20092-01-001

**Proposed Residential Development
Clonattin, Gorey**

**STAGE 1 QUALITY AUDIT
(incorporating an access, cycling, walking
and road safety audit)**

4.2 Issue:

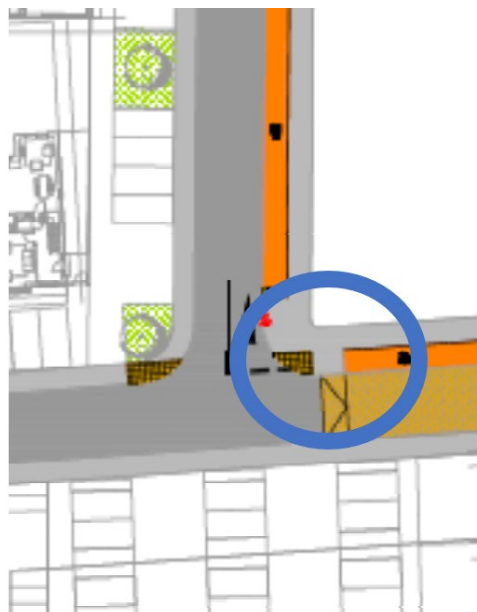
The informal pedestrian crossings at the junctions are all located at the widest crossing location. At one location the crossing leads pedestrians into the cycle lane.

Move the crossings to the end of the turning arc to reduce the crossing width.

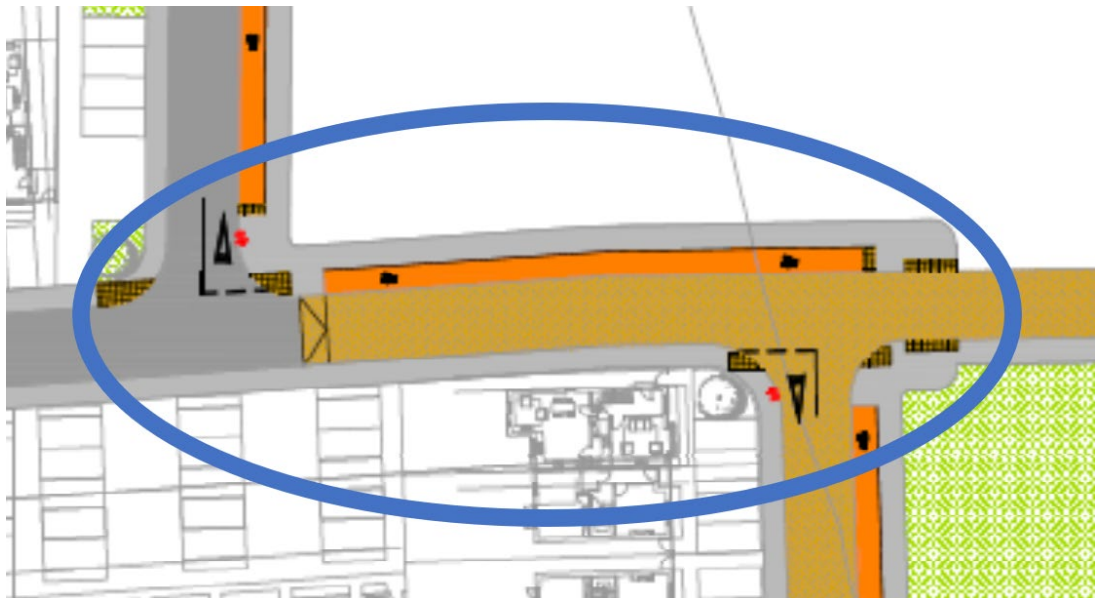
- 4.3 Issue:
Pedestrian crossings are not generally provided on the wider circulatory roads which are likely to have vehicles travelling at higher speeds than in the home zones.

Provide adequate pedestrian crossing facilities on all roads.

4.7 Issue:

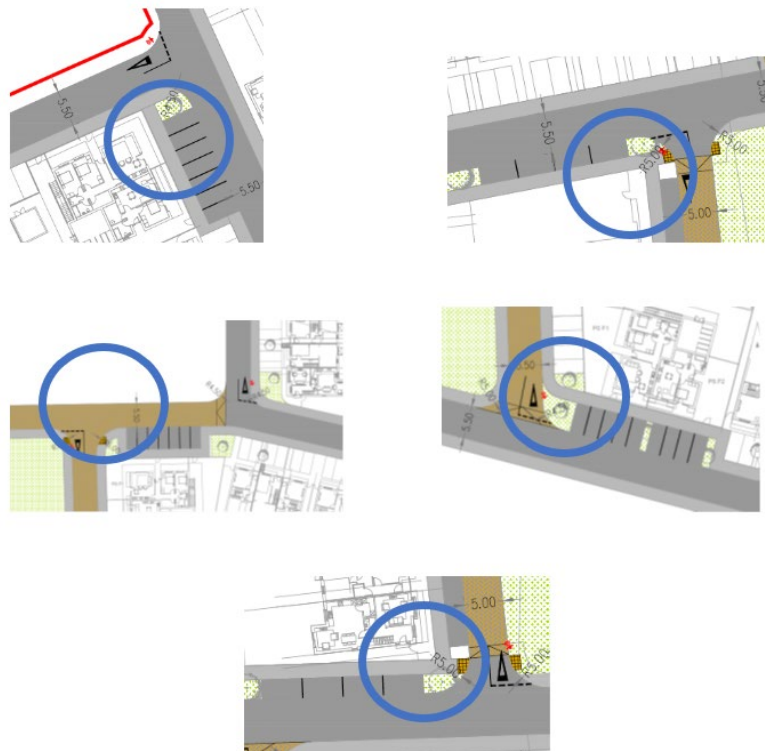
There is no connection from the internal off-road cycle track and the off-road cycle tracks on the cinema road.

Provide an off-road cycle track connection to the cinema road.

4.9 Issue:

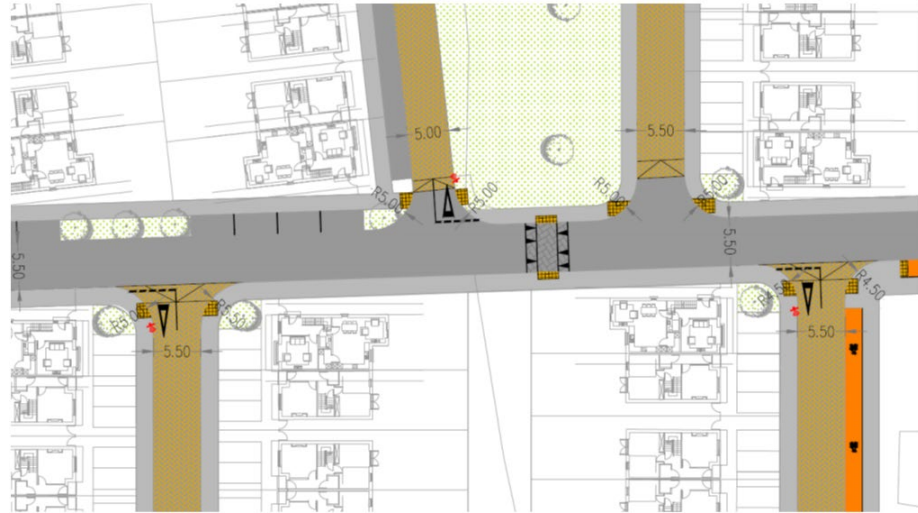
In some of the home zones the pedestrian crossing is located inside the home zone on the raised area while in others it is not. Locating the pedestrian crossing within the home zone offers greater protection to vulnerable road users.

The upper junctions have pedestrian crossings outside the home zone whereas the lower junctions have the crossings within the home zone.

Locate the pedestrian crossing within the home zone.

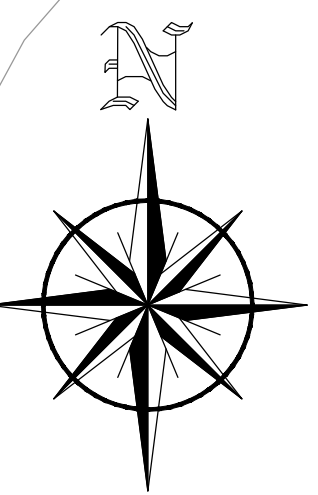
Cyclists, on the on-road cycle track, are at risk of collision with turning vehicles at car park entrances and the bus bay.

Provide colour contrast on the cycle track surface at these locations.
